RE: Eberle Well Field/ Sections 31 and 32, Township 1N, Range 66W, 6th PM, Weld County
Application for Permit/Synergy Resources Corporation

Oil and Gas Location Assessment (02A) Document No. 400534013 Well No. B-32CHZ
Oil and Gas Permit (02) Document No. 400534181 Well No. B-32CHZ
400534291 Well No. 13-32CHZ
400534691 Well No. B-32NHZ
400534718 Well No. 14-32-31NHZN
400534808 Well No. 14-32-31CHZM
400534516 Well No. 13-32NHZ

Upon review of the information provided by Synergy including the recently provided Location Stormwater Plan, the City, especially the Stormwater Management division, has the following additional concerns and specific observations:

LOCATION STORMWATER PLAN

1 EBERLE WELLS STORMWATER PLAN

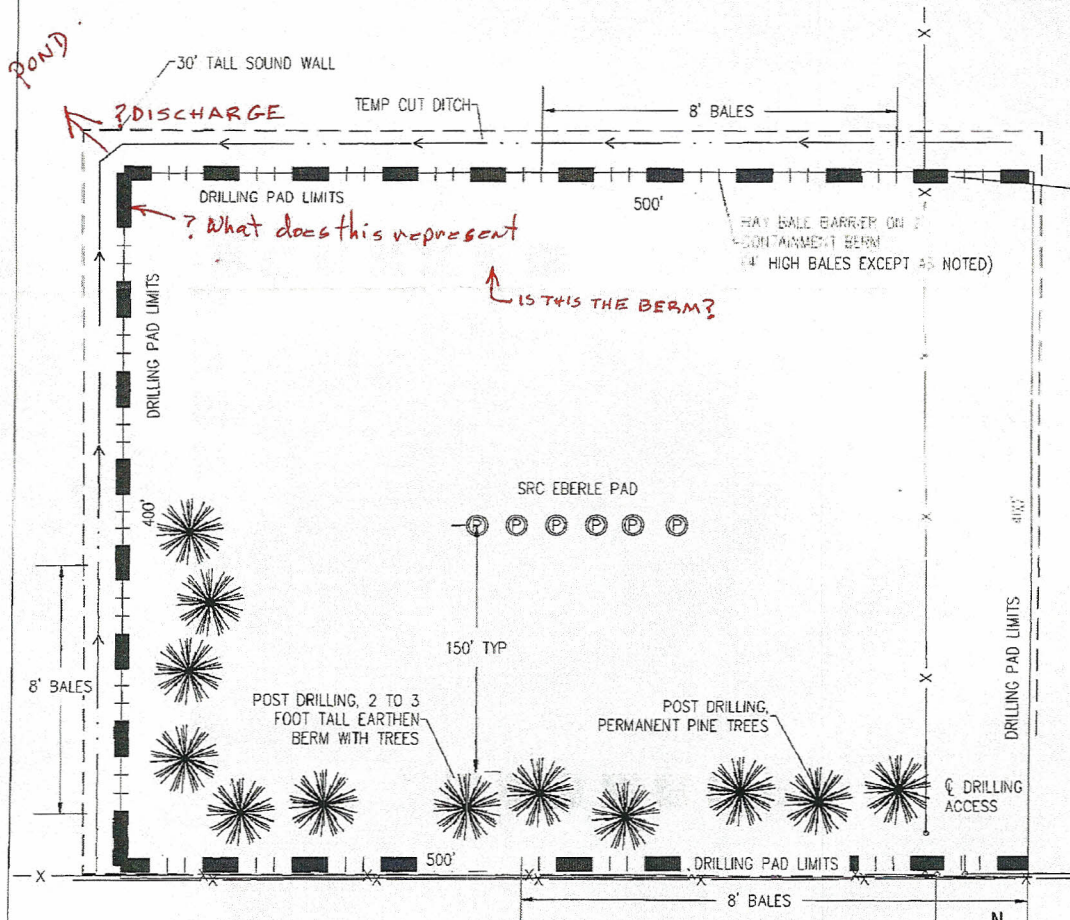
1. Indicate specific location of buffer zone – distance between Fulton ditch and Oil/Gas operations.
2. Indicate contours, slopes, gradient and flow direction.

3. It is not clear how much surface will be impervious, how much runoff is expected and whether or not the proposed ditch around the pad will be able to carry flows. Where does the diversion ditch around the pad flow into?

10. It is not clearly indicated where the hay bale wall and ditch around the perimeter will be placed; will there be a culvert installed to cross the proposed ditch?

BALES ONLY at the three locations?
